# INDIANA DEPARTMENT OF TRANSPORTATION

## APPROVED MINUTES

### January 20, 2011 Standards Committee Meeting

RE: Minutes for the January 20, 2011 Standards Committee Meeting

TABLE RPPG-2

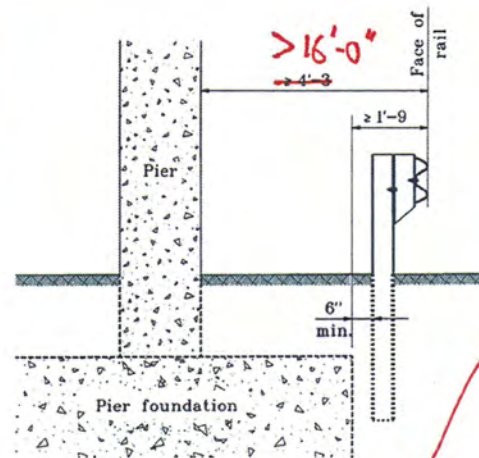
VARIATION OF THIS  
DETAIL TO NEW STD  
DWG E 601-GRBS-01

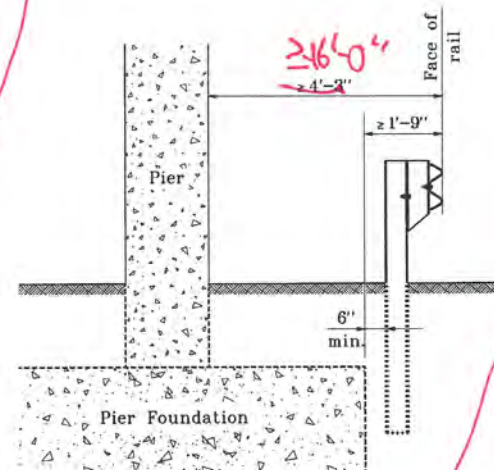
VARIAION OF THIS  
DETAIL TO NEW STD  
DWG E 601-6685-01

**BRIDGE-RAILING-END PROTECTION REQUIREMENTS****Figure 49-9A**

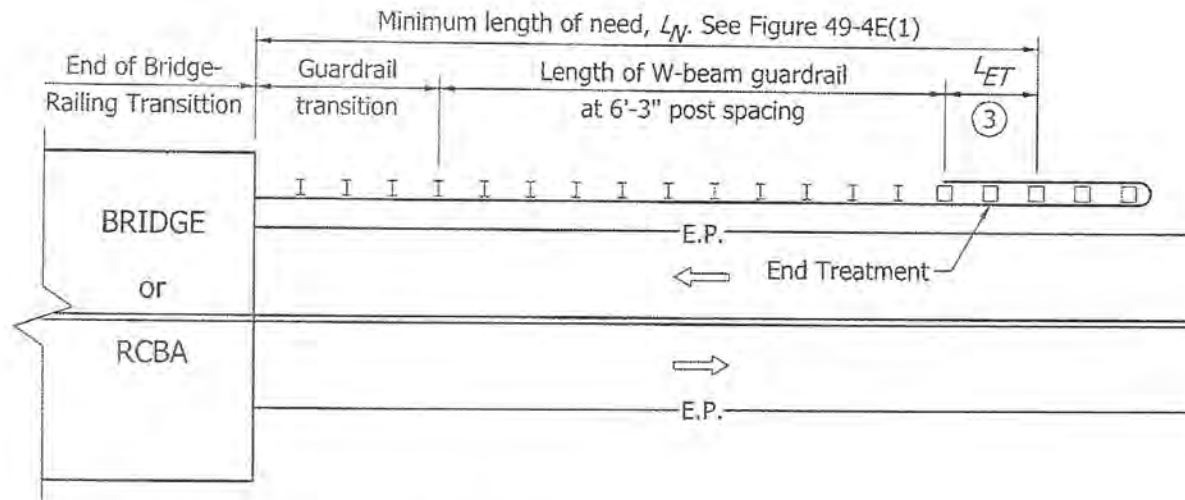
DELETE, AS TABLE DATA RESEMBLE,  
SO ARE THEREFORE SUPERSEDED,  
BY DATA IN NEW FIG 49-4E(1)

601-RPPG-01 ROADSIDE PIER PROTECTION GUARDRAIL (PROPOSED TO DELETE)

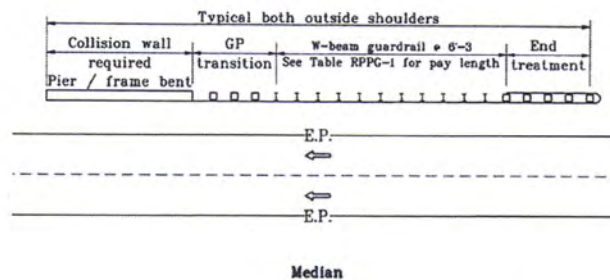
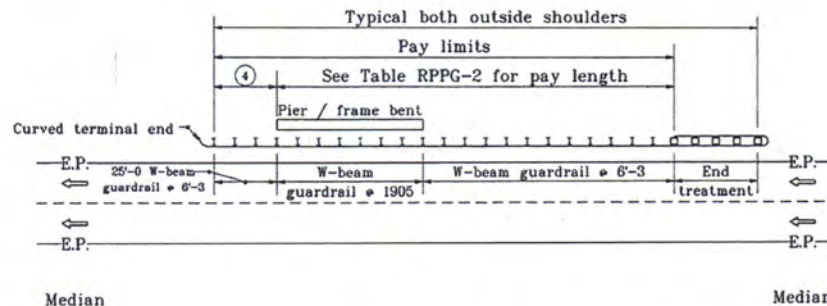
THIS NOTE IS ADDRESSED  
ON NEW STD DWG  
E 601-GRBS-01

DELETE THIS  
STD DWG

## 601-RPPG-02 ROADSIDE PIER PROTECTION GUARDRAIL (PROPOSED TO DELETE)

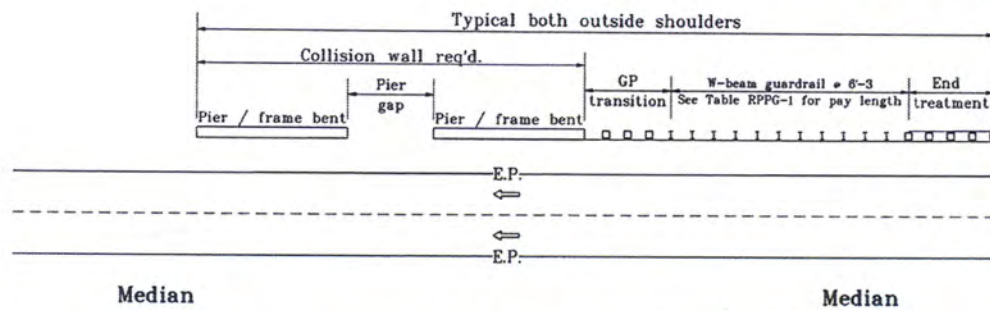
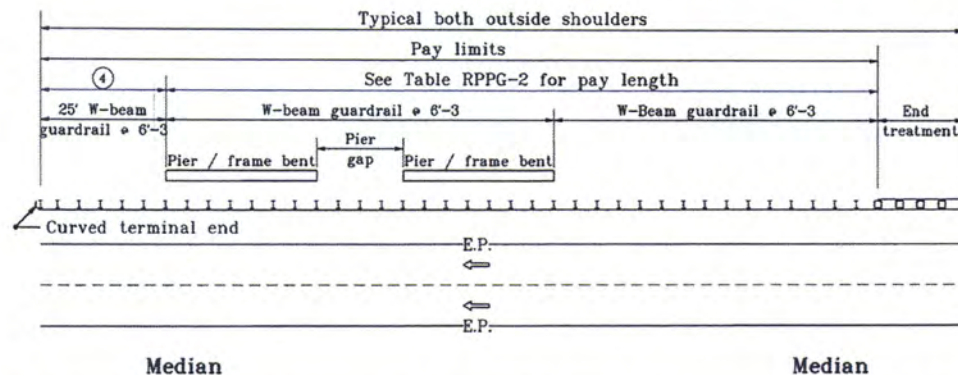
DELETE THIS  
STD DWG

601-MPPG-04 MEDIAN PIER PROTECTION GUARDRAIL (PROPOSED TO DELETE)

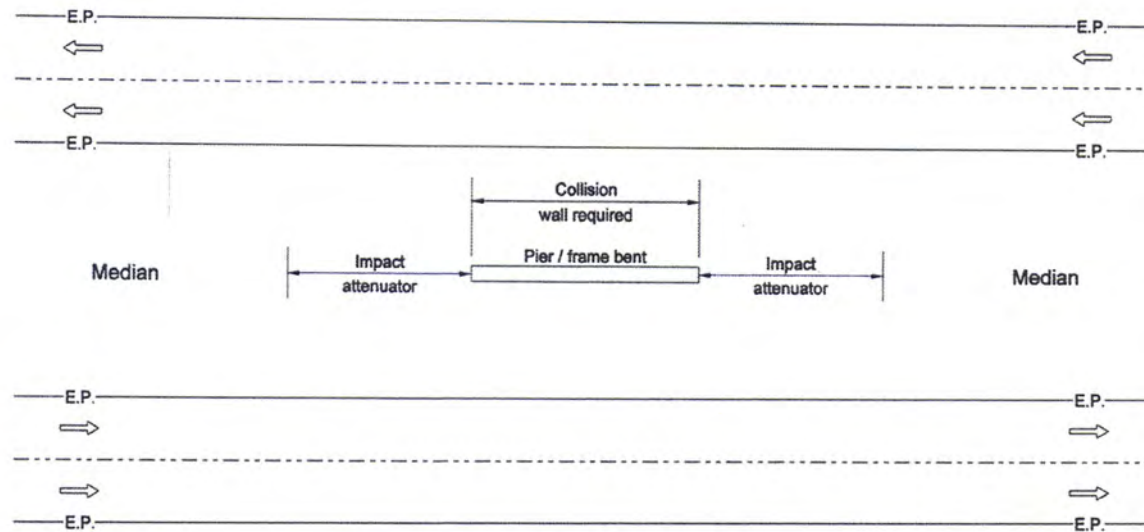
VARIATION OR DETAIL  
TO NEW IDM  
FIG 49-4E(8),  
DETAIL (a)

601-MPPG-03 MEDIAN PIER PROTECTION GUARDRAIL (PROPOSED TO DELETE)

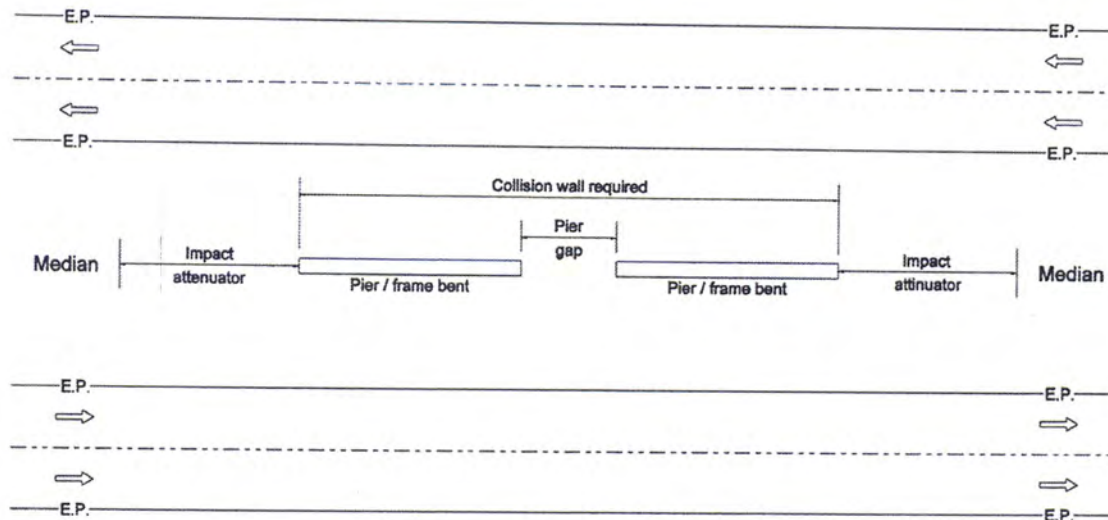
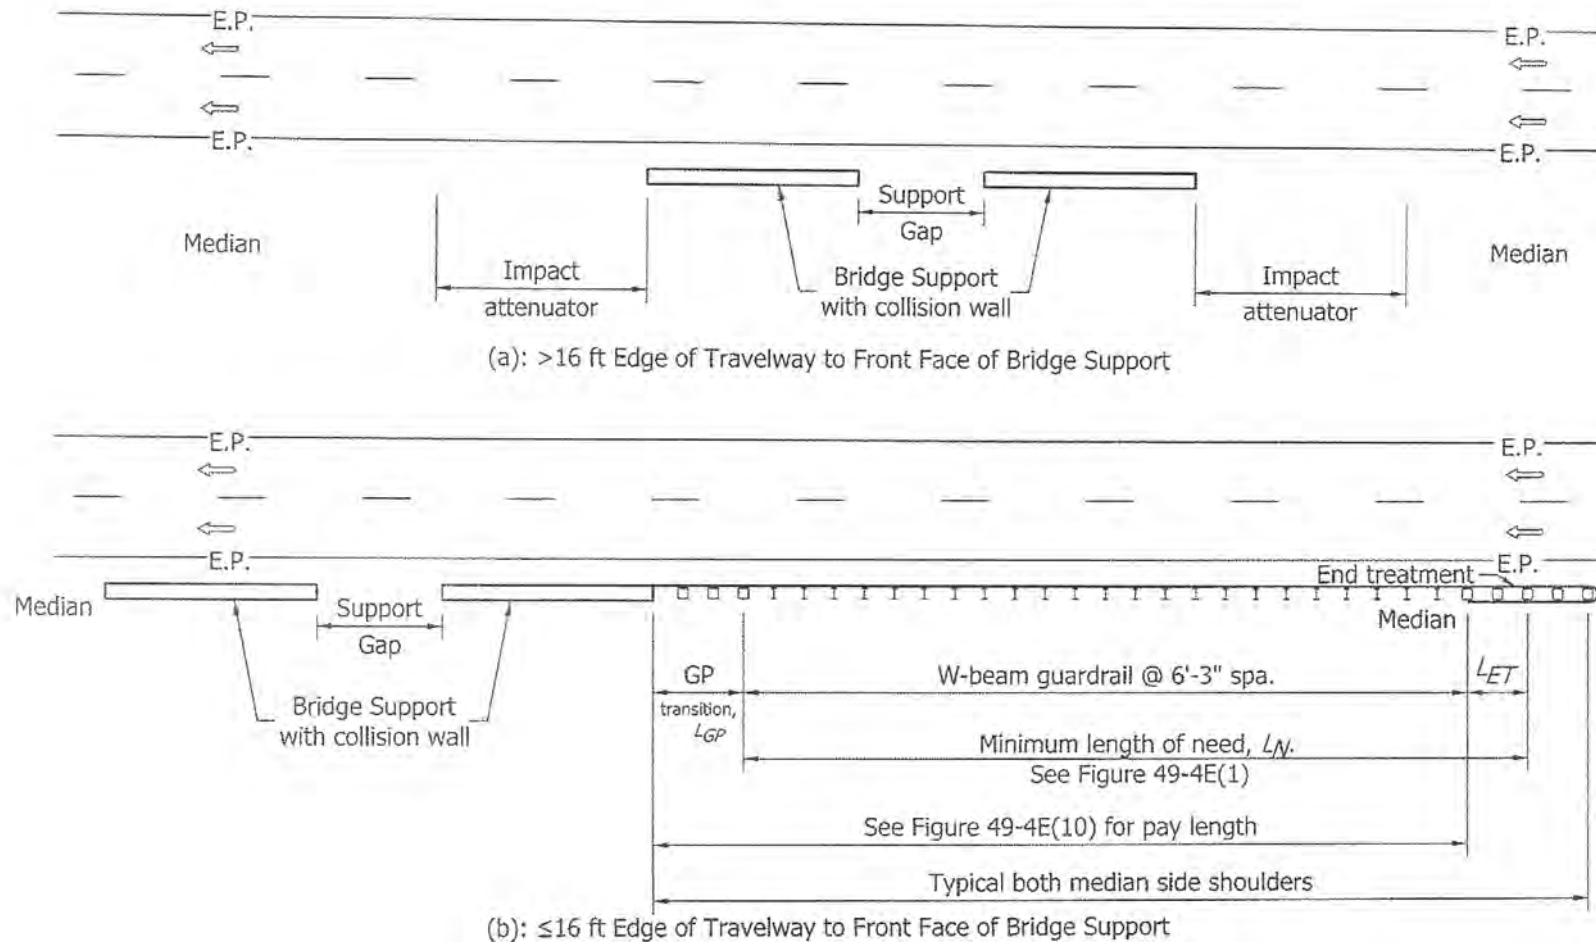
DELETE THIS  
STD DWG

VARIATION OF DETAIL  
TO NEW IDW  
R16 49-4E(9),  
DETAIL (a)

DOWNSTREAM GUARDRAIL  
AT BRIDGE SUPPORT  
STD. DWG. No. E601-GRBS-01

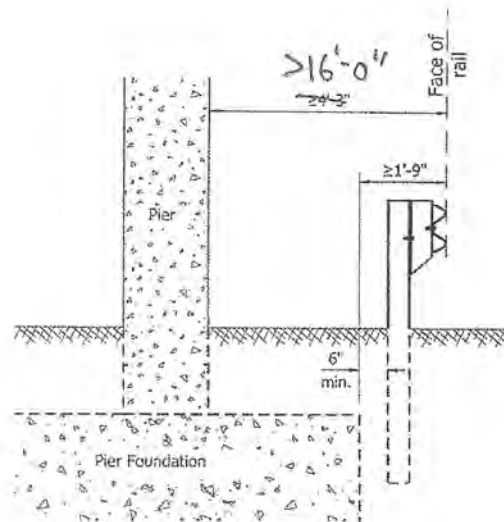
INCLUDE ON  
NEW STD DWG THAT  
ADDRESSES NOTE ④ ON  
DWG 601-RDPG-01

## BACKUP 1. EXISTING STANDARD DRAWING 605-CCCG-01 COMBINED CONCRETE CURB AND GUTTER

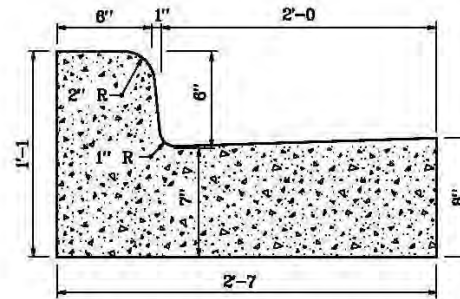
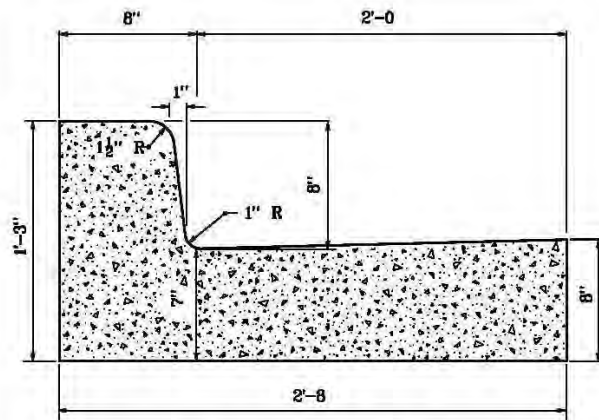
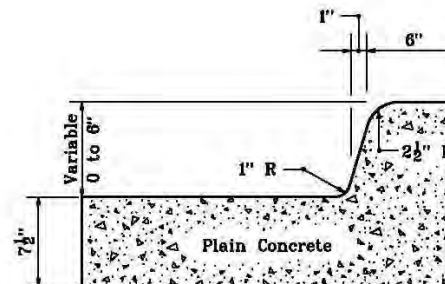
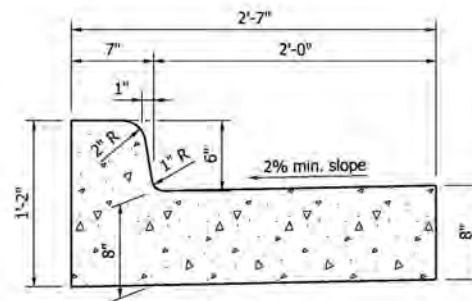
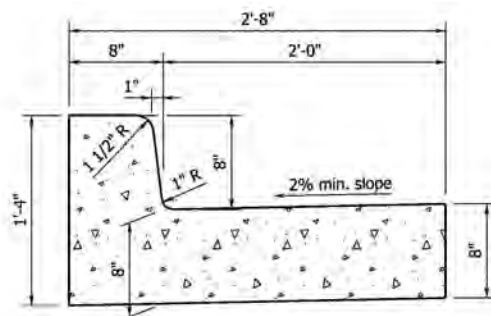
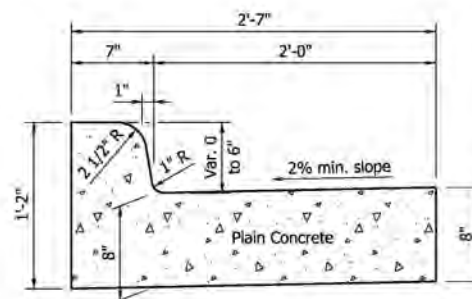
<u>Item No. 11 01/20/11 (2010 SS)</u>	<u>Mr. Wright</u>	<u>page 161</u>
Standard Drawing:		
605-CCCG-01	COMBINED CONCRETE CURB AND GUTTER

ACTION: PASSED AS REVISED
